Item Name: Replacement Skidtube, High Gear with Standard Wearplates Fits LH or RH

Draw Nbr	Revision Nbr
D2650	Rev F(DEO)

DRAWING NO. D2650	TITLE 206/407 SKIDTUBE ASSEMBLIES	REV. F	DART AEROSPACE LTD ENGINEERING ORDER		D.E.O. NO. D2650-F-1	SHEET NO. SHEET 1 OF 1	SCALE NTS
DRAWN <i>[Signature]</i>	CHECKED A.P.	MFG. APPR. <i>[Signature]</i>	APPROVED <i>[Signature]</i>		DE APPR. <i>[Signature]</i>		
DATE 12.10.12	DATE 12.10.22	DATE 12.10.22	DATE 12.10.22		DATE 12.10.22

CHANGE C'BORED WELDED CROSSBOLT SPACERS TO SWAGED SPACERS

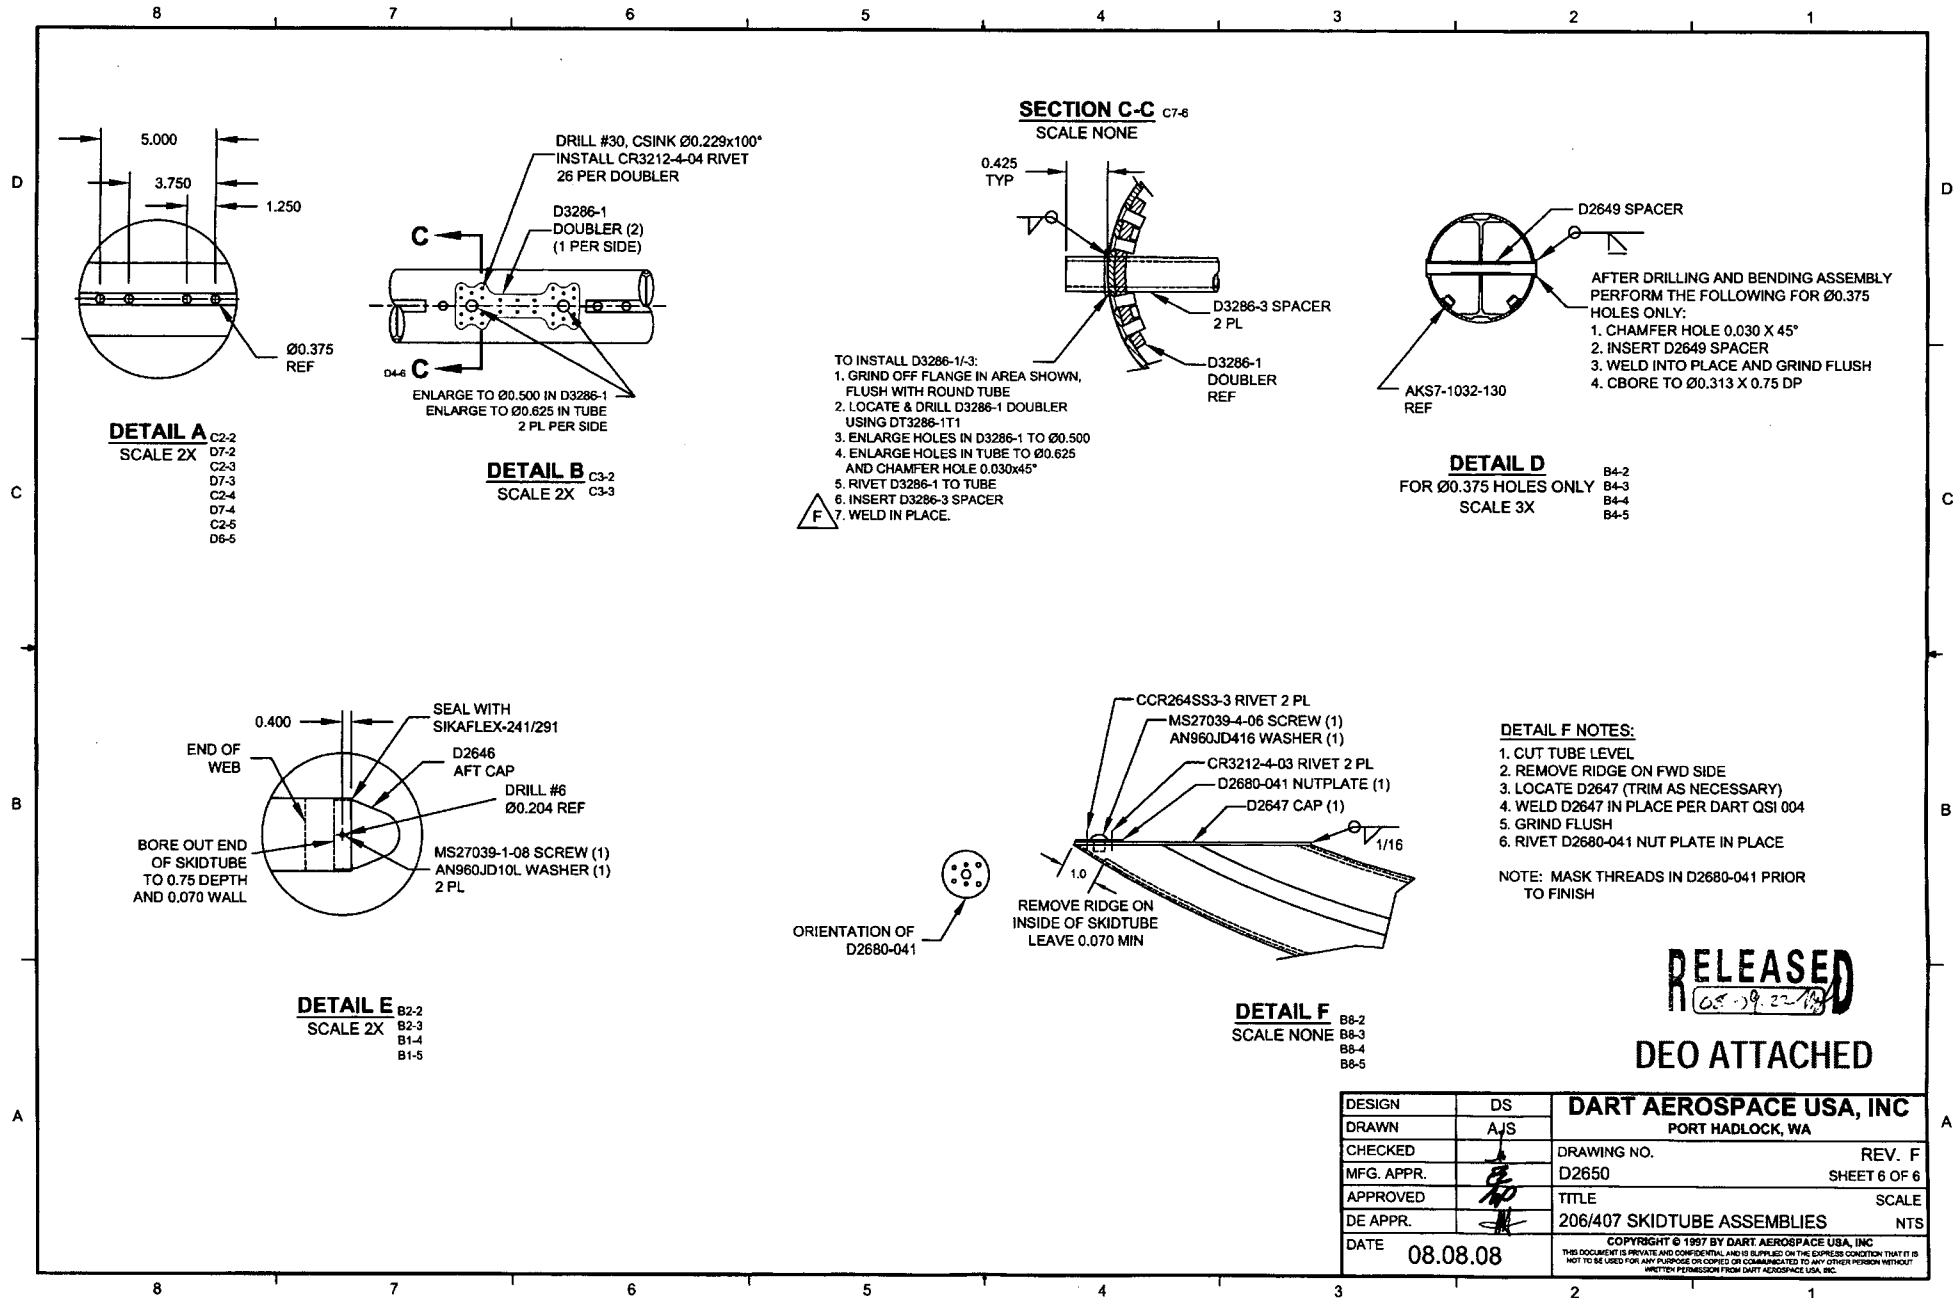
PARTS LIST IS AMENDED AS FOLLOWS:

IS:

QTY	QTY	QTY	QTY	PART NUMBER	DESCRIPTION
-1	-3	-5	-7		
1	1	0	0	D2649	CROSS BOLT SPACER
16	17	19	23	D4720-1	SPACER

WAS:

17	18	19	23	D2649	CROSS BOLT SPACER
----	----	----	----	-------	-------------------

ADD DETAIL G BELOW, WHICH IS THE SAME SECTION VIEW AS DETAIL D OF DWG.

DETAIL G

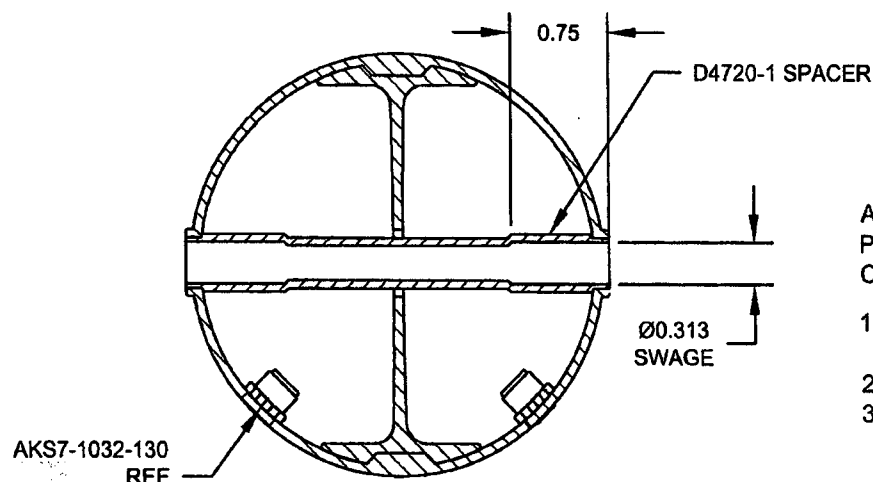
C'BORED HOLES ARE NOW SWAGED PER DETAIL G BELOW. FOR THE Ø0.375 HOLE THAT IS NOT C'BORED, WELD PER DETAIL D OF DWG (SEE AMENDED DETAIL B FOR REFERENCE).

FOR Ø0.375 HOLES ONLY

FOR HOLES THAT ARE CURRENTLY C'BORED ONLY

AFTER DRILLING AND BENDING ASSEMBLY
PERFORM THE FOLLOWING FOR Ø0.375 HOLES THAT ARE
CURRENTLY C'BORED:

1. INSERT D4720-1 SPACER, 16 PL (-1) OR 17 PL (-3)
OR 19 PL (-5) OR 23 PL (-7)
2. SWAGE TO Ø0.313 X 0.75 DP PER QSI 002
3. TRIM / GRIND FLUSH PER QSI 002
